BRIEF PROJECT DESCRIPTION: 3rd PARCEL MAP FOR NEV DEV LLC

Re: Pre-check: 3rd Parcel Map for Nev Dev LLC

MAP NAME: 3RD PARCEL MAP FOR NEV DEV LLC

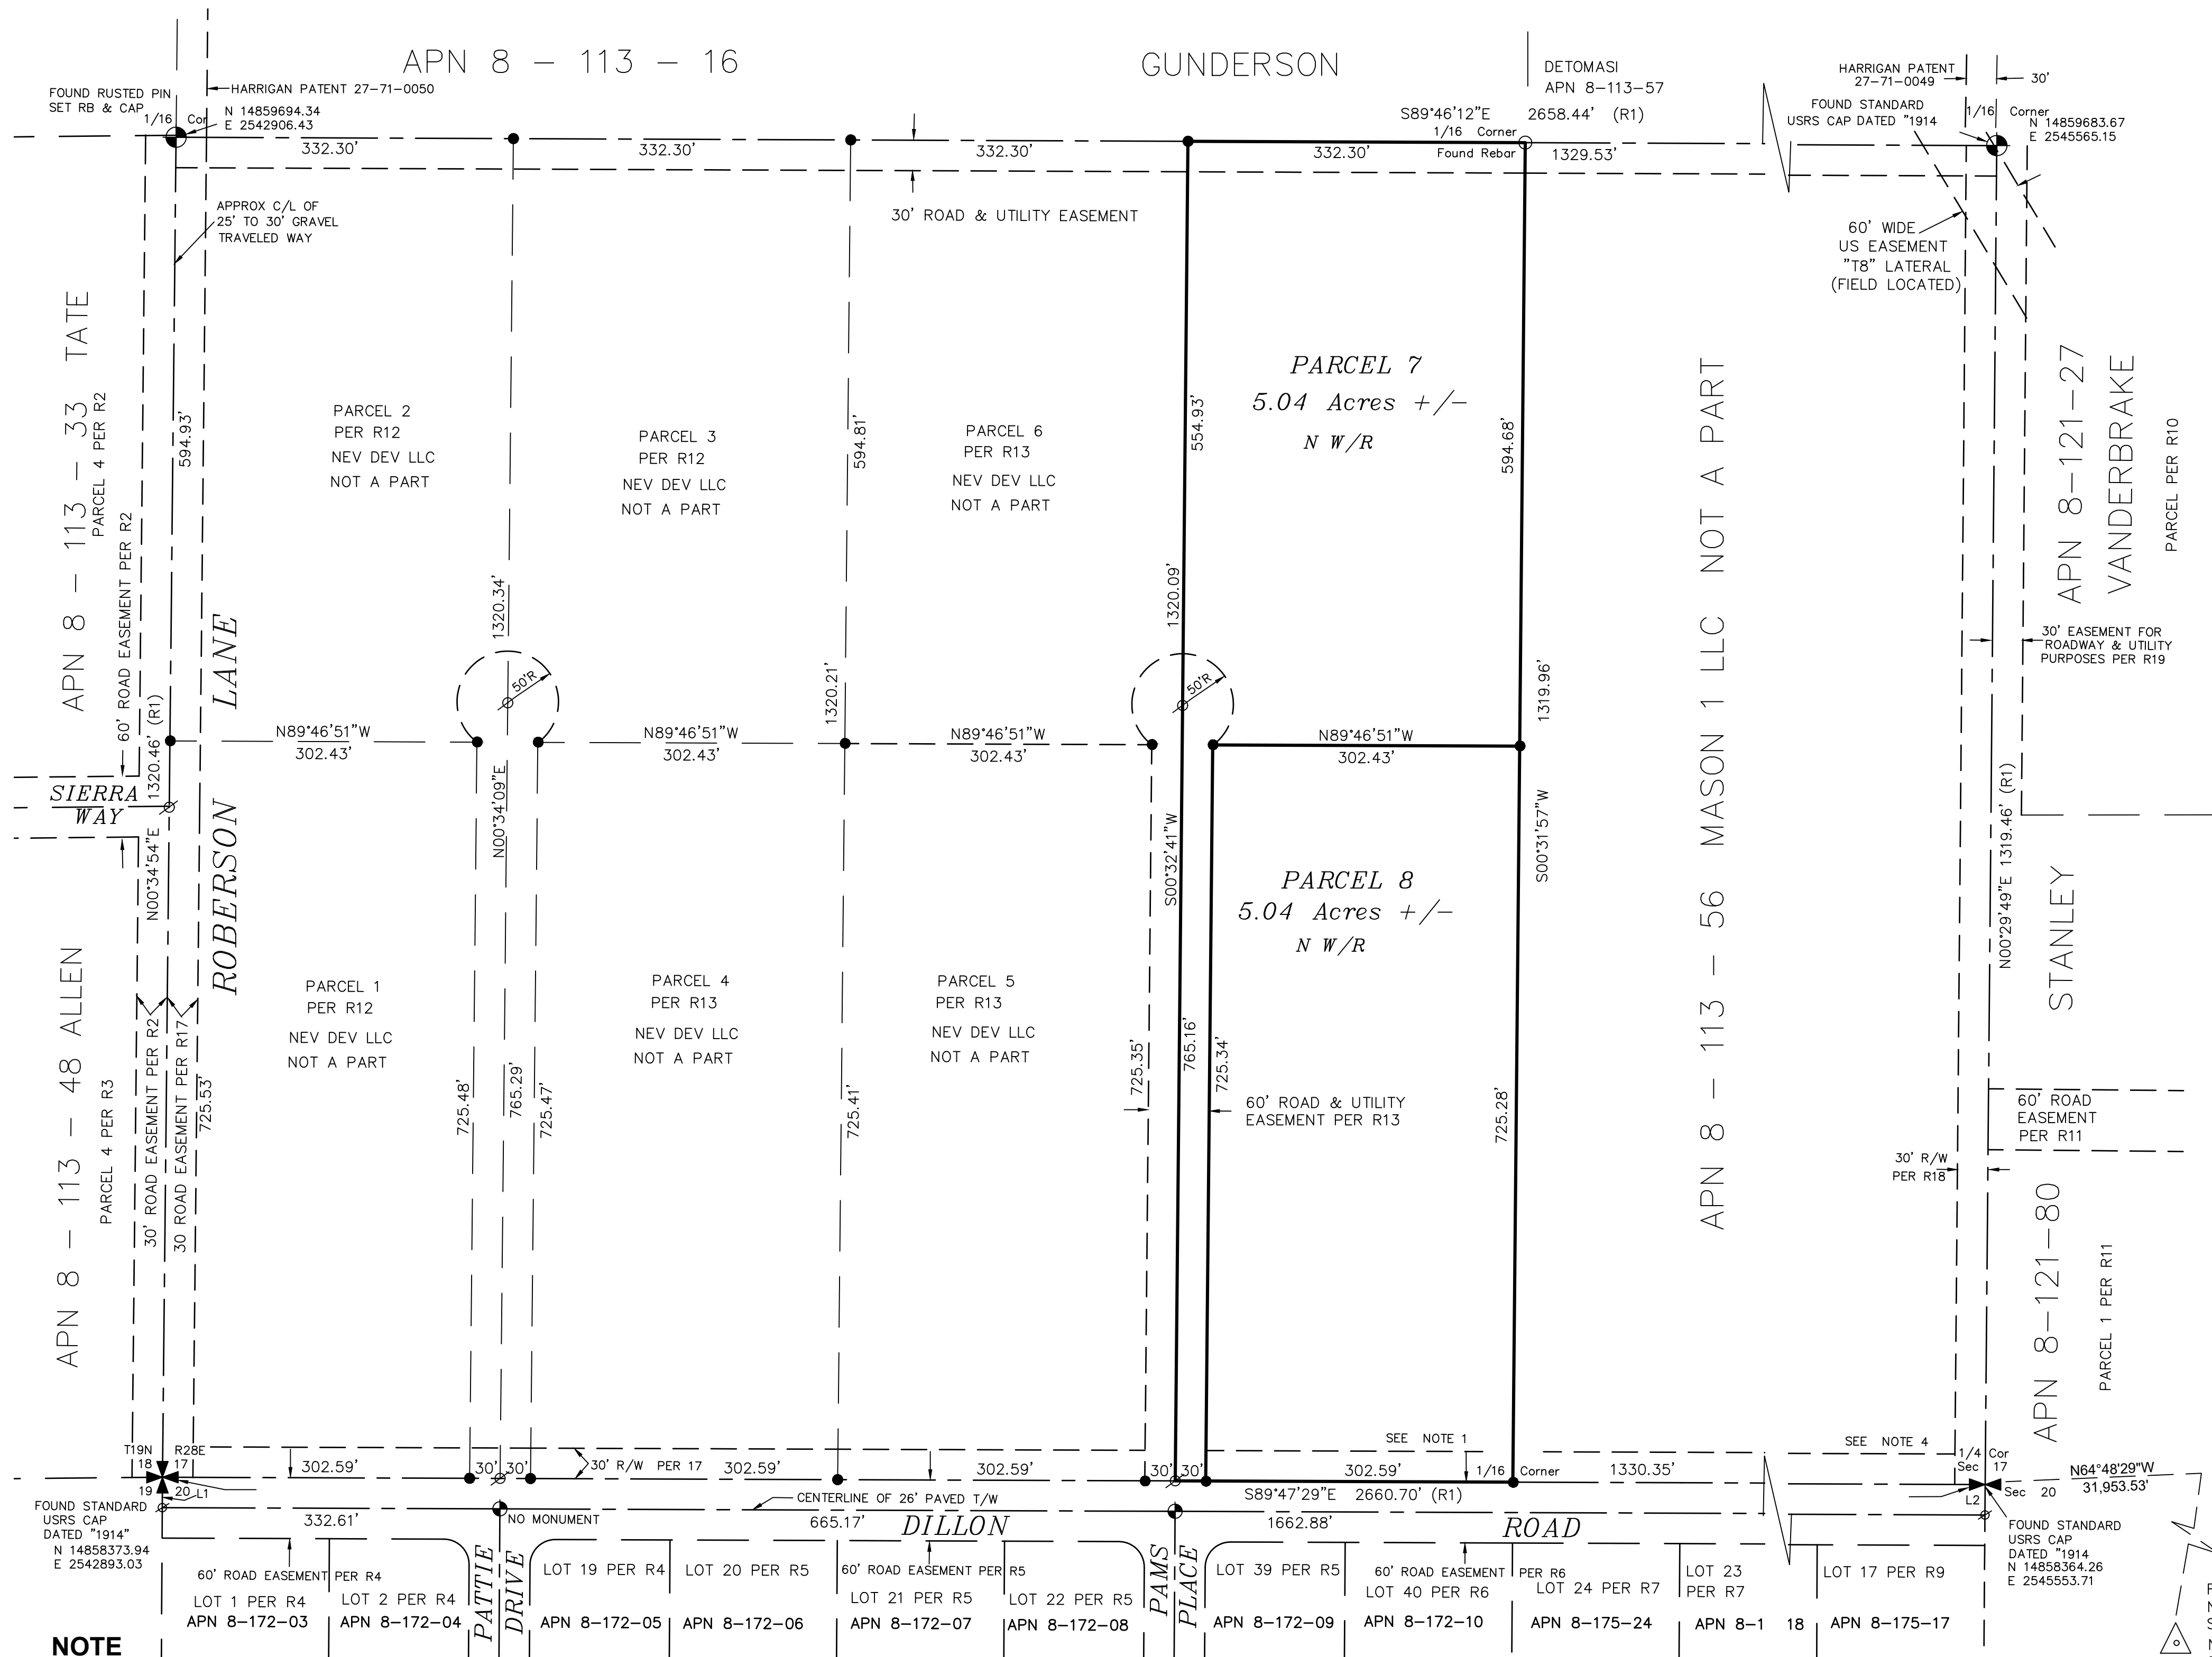
TITLE BLOCK: ADD PRIOR RECORDED MAP #

SHEET
2
 OF 2

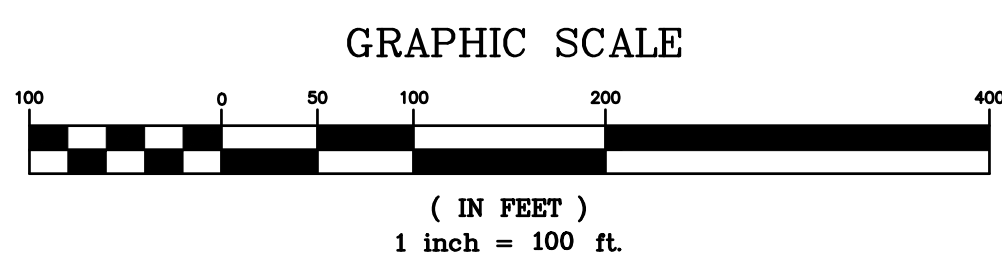
1. A wet stamp and original signature are required for all documents submitted for recording.
2. Add "or as noted" to the center line symbol description in the legend.
3. It appears there are no witness corners, you should remove the witness corner symbol in the legend
